VESSEL'S NAME LEME REPORT Nap. No. 4309

of Survey PERIODICAL SPECIAL SURVEY (D) due 8.46.

THICKNESSES OF PLATING ascertained by drilling, and comparison of same with the original thicknesses.

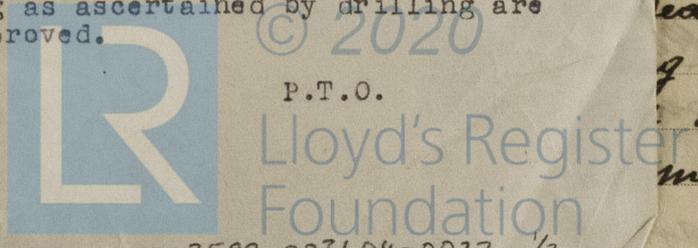
Drillings at ends to be made in the vicinity of the peak bulkheads.

Overflow pipes (p & s) required to be removed, repairs to windlass to be further examined and permanent repairs are required to fractured and indented shell plating, etc. in 1st strake above and below sheerstrake (p.s.) and to forward deep tank (No. 5 hold) at the first opportunity, also to (30 fathoms of chain cable required to be supplied).

The thicknesses of shell plating as ascertained by drilling are shown above and are such as could be approved.
